APPENDIX E.8.4

INAC INSPECTION REPORTS AND BAFFINLAND RESPONSES

WATER LICENCE INSPECTION FORM

Figure 1 (HATCH drawings confirming the required culvert)

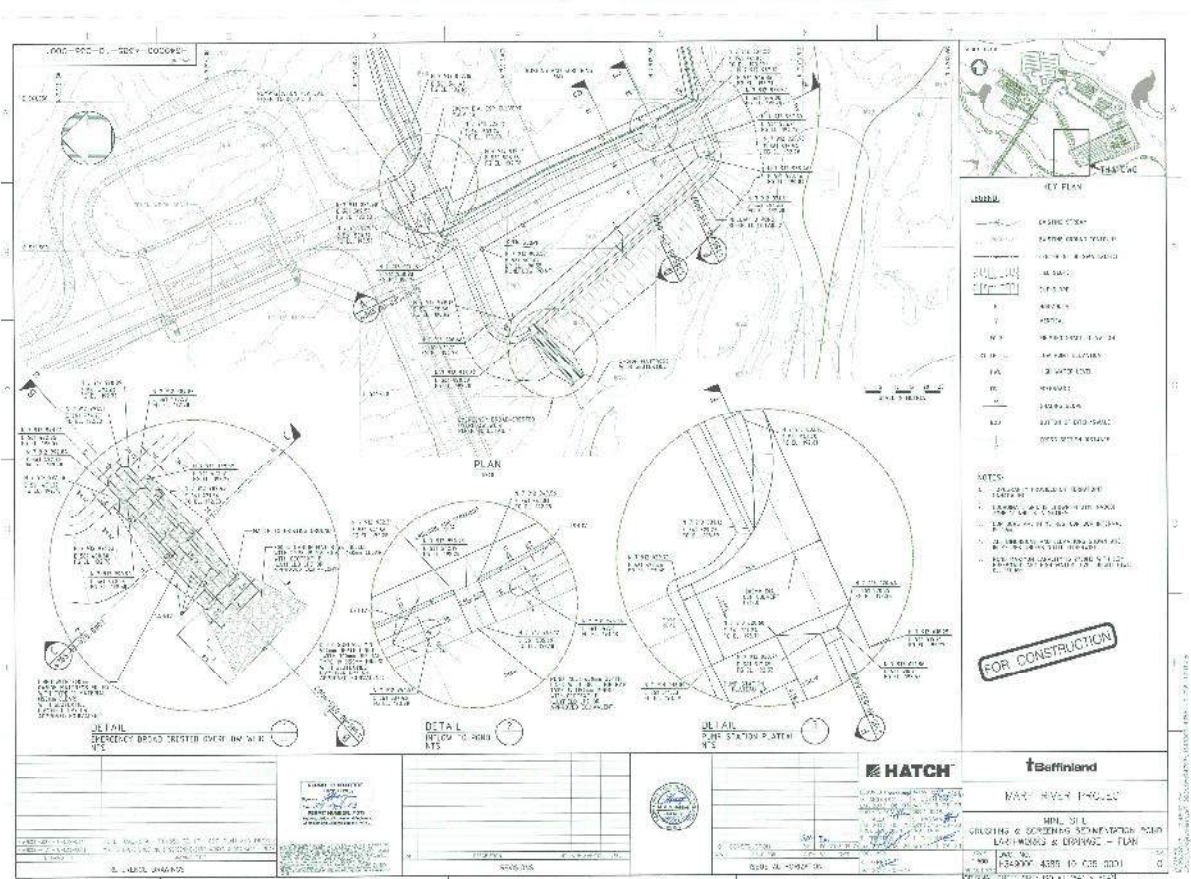
- c. During the Inspection it was noted that there was no culvert in place to allow water from the North West unlined ditches to enter the sedimentation pond, this is a concern to the inspector because in the HATCH for construction drawings below (Figure 1) it shows that there should be a 1000mm DIA CSP culvert installed.
